AMENDMENT NO. 2 NOVEMBER 1989
TO
IS : 10198 - 1982 SPECIFICATION FOR CARBON
STEEL, SAFETY RAZOR BLADES

All dimensions in millimetres
FIG. 3 STAINLESS STEEL SAFETY RAZOR BLADE (PIN TYPE)

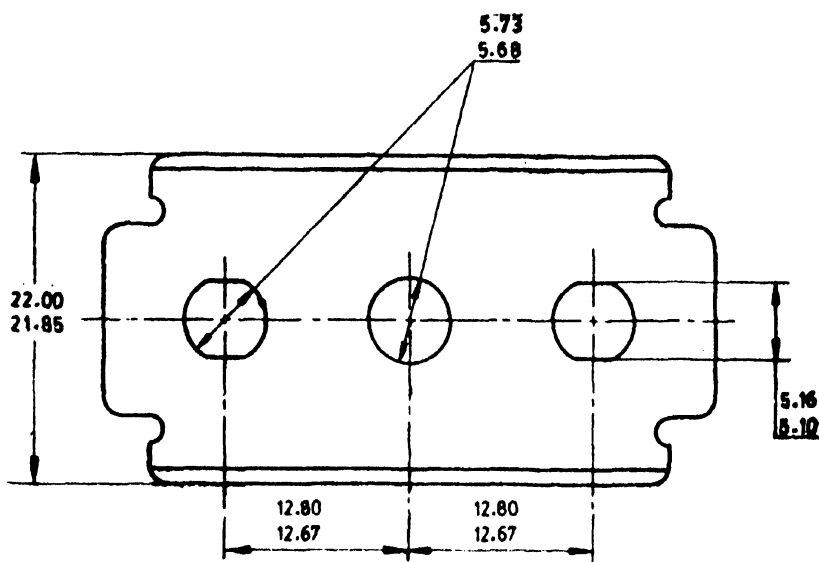
(Page 4, clause 5.1.1) — Insert the following new clause 5.1.2 and Fig. 3 after 5.1.1:

'5.1.2 The critical dimensions of the blade for pin type razor shall be as shown in Fig. 3.'
